UNITED STATES PATENT AND TRADEMARK OFFICE

APPLICATION NO.	FILING DATE	FIRST NAMED INVENTOR	ATTORNEY DOCKET NO.	CONFIRMATION NO.
10/530,563	04/07/2005	Takao Hasegawa	040894-7216	8997
9629	7590	02/05/2007	EXAMINER	
MORGAN LEWIS & BOCKIUS LLP 1111 PENNSYLVANIA AVENUE NW WASHINGTON, DC 20004			REYNOLDS, STEVEN ALAN	
ART UNIT		PAPER NUMBER		3728
SHORTENED STATUTORY PERIOD OF RESPONSE	MAIL DATE	DELIVERY MODE		
3 MONTHS	02/05/2007	PAPER

Office Action Summary	Application No.	Applicant(s)	
	10/530,563	HASEGAWA ET AL.	
	Examiner	Art Unit	
	Steven Reynolds	3728

F I G . 2

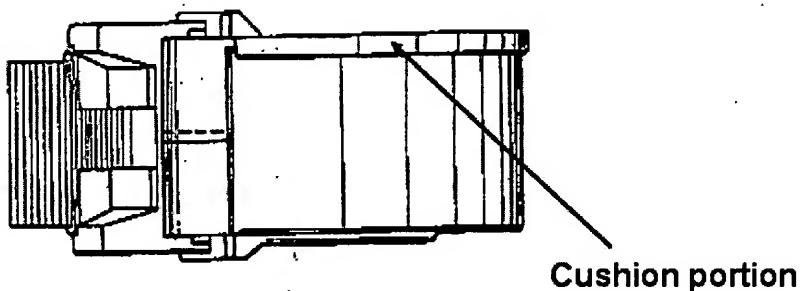
5. Claims 10-12, 14, 17 and 19 are rejected under 35 U.S.C. 102(b) as being anticipated by Garfinkel (US 3,602,414). Garfinkel discloses a staple case that contains a roll staple (19) formed by connecting unformed staples in a roll; a pull-out opening

through which the roll staple is pulled out (See Fig. 5 embodiment); a cushion portion (See figure below); a first case half (13) and a second case half (14); and a weak portion (hinge member 15) on a joint between the first case half and second case half.

Regarding claim 12, since no reference point for the orientation of the case is claimed, the case of Garfinkel can be oriented in a position where the pull-out opening is at a vertical center of a front face.

Fig. 4

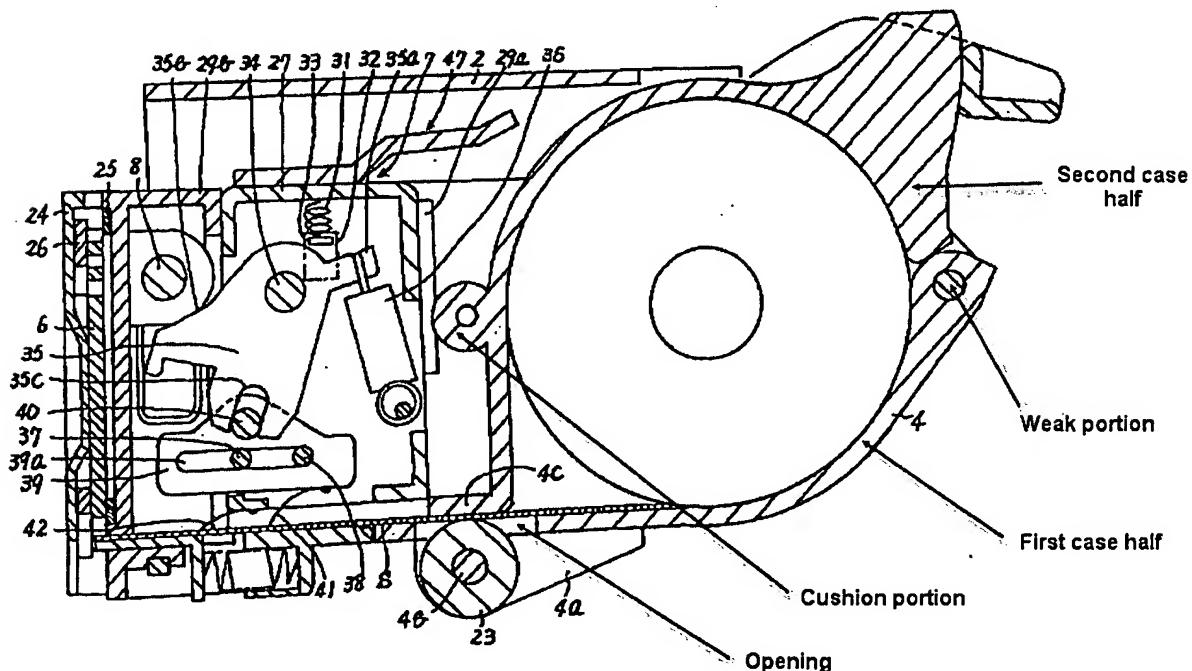
6. Claims 10, 11 and 13-19 are rejected under 35 U.S.C. 102(e) as being anticipated by Mochizuki (US 6,568,579). Mochizuki discloses a staple case (cartridge 4) that contains a roll staple formed by connecting unformed staples in a roll shape; a pull-out opening (opening wherein staples S pass beneath plate 4 – See Fig. 4 embodiment) through which the roll staple is pulled out; an opening (opening in lower portion of cartridge 4 wherein roller 23 is positioned – See Fig. 4 embodiment and Figure below), formed at a part of the staple case facing a circumferential surface of the roll staple, through which a member (roller 23) for rotating the roll staple is brought into contact with the roll staple (See column 5, lines 21-26); a cushion portion (See figure

below); a portion for positioning in a containing chamber (45 slides into 43 to position the cartridge into the containing chamber 2); a guide portion for guiding the staple case to a containing chamber (46 slides into 44 to guide the cartridge into the containing chamber 2); a first case half and a second case half (See Figure below); a first opening (opening wherein staples S pass beneath plate 4 – See Fig. 4 embodiment) through which the roll staple is pulled out; and a second opening (opening in lower portion of cartridge 4 wherein roller 23 is positioned – See Fig. 4 embodiment and Figure below) through which a member for rotating the roll staple is brought into contact with the roll staple, wherein the first opening is provided on the second case half, and the second opening is provided on the first case half (See Figure below); and a weak portion (hinge – See Figure below) on a joint between the first case half and the second case half.

9. Claims 20 and 21 are rejected under 35 U.S.C. 103(a) as being unpatentable over Mochizuki (US 6,568,579) in view of Haramiishi (US 7,048,165). Mochizuki discloses an upper/front face (Second case half – See Figure above) and a bottom/back face (First case half – See Figure above) having a different shape to the upper face. Mochizuki discloses all the limitations of the claims except for the specifics of the markings on the staple case.
